Access Compliance Report

Public Rights-of-Way

(Curb Ramps)

Intersection ID: 25985	Main Street: BROOK_HOLLOW_RD	Cross Street: MEADOW_HAVEN_LN	Location: SW
ADA ID: 982FCFEAF6BB	Ramp Type: Perp	Initial Pass/Fail: Fail	Overall Compliance: No
Severity Score: 13.75			
Codes/Mitigation Info/Possible Solution		Field Measurements/Component Compliance

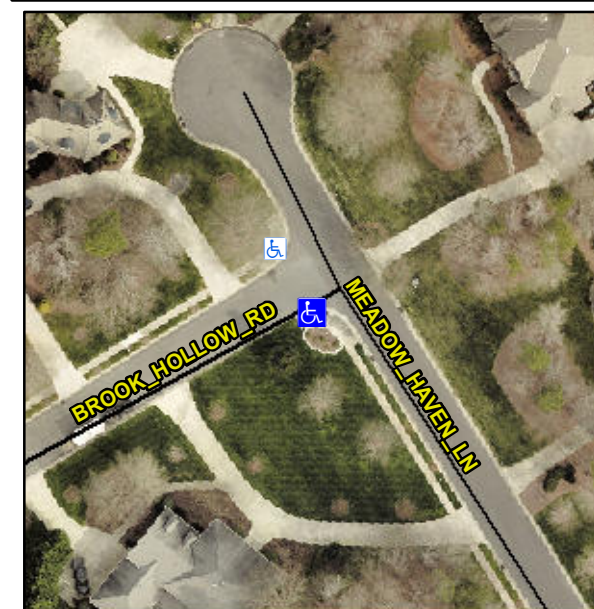
R304.2.2, R304.5.3

Compliance	Description	Data	Compliance	Description	Data
N/A	Ramp Length (in)	59.0	No	Ramp Slope (%)	8.8
Yes	Ramp Width (in)	48.0	No	Ramp XSlope (%)	3.7
N/A	Flare Type LT	N/A	N/A	Flare Type RT	N/A
N/A	Flare Slope LT (%)	N/A	N/A	Flare Slope RT (%)	N/A
N/A	Flare Traversable LT?	N/A	N/A	Flare Traversable RT?	N/A
N/A	Landing Length (in)	N/A	N/A	DWS Provided?	N/A
N/A	Landing Width (in)	N/A	N/A	DWS Contrast?	N/A
N/A	Landing Slope (%)	N/A	N/A	DWS Length (in)	N/A
N/A	Landing X Slope (%)	N/A	N/A	DWS Full Width?	N/A
N/A	Landing Curb? (Y/N)	N/A	N/A	DWS Offset (in)	N/A
N/A	Shared Landing?	N/A			
N/A	Gutter Ponding?	N/A	N/A	Gutter Slope (%)	N/A
N/A	Gutter Lip Ht (in)	N/A	N/A	Gutter X Slope (%)	N/A
N/A	Painted X Walk1?	No	N/A	Painted X Walk2?	N/A
	X Walk 1 Direction	To N		X Walk 2 Direction	N/A
N/A	X Walk 1 Width (in)	N/A	N/A	X Walk 2 Width (in)	N/A
	X Walk 1 Slope (%)	0.3		X Walk 2 Slope (%)	N/A
	X Walk 1 X Slope (%)	2.9		X Walk 2 X Slope (%)	N/A

Remove & Replace Entire Ramp.
